Countries: CANADA, UNITED STATES
Document ID: IK2200018
Availability: ISIS, FleetISIS
Revision: 5
Major System: BUS BODY
Created: 1/14/2007
Current Language: English
Last Modified: 8/9/2013
Other Languages: [Français](#), [Español](#),
Author: Bob Ford
Viewed: 392

Title: Reinforcement of the Battery Box CE RE FE and BE Buses

Applies To: Model: Bus Start Date: 03/09/1999 End Date: 12/12/2006

Before Repair

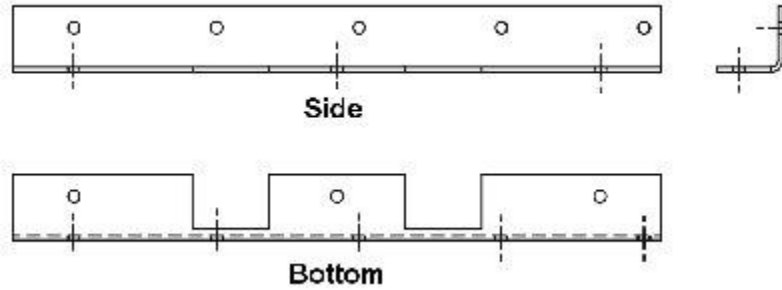
On some bus models the bottom of the battery box may deform, or begin to separate from the sides of the box under the weight of the vehicle's batteries. A field kit that contains two corner supports and fasteners, for reinforcement of the battery box is now available to address this issue.

After Repair

Part No.	Description	Quantity
2592799C91	Battery Box Reinforcement Kit	
	Contents:	
2592800C1	Instruction Sheet, Battery Box Reinforcement Kit	1

2592801C1	Support, Reinforcement Angle (Figure 2)	2
424329001	Rivet, 1/4 Huck Magna Bulb (Figure 3)	16
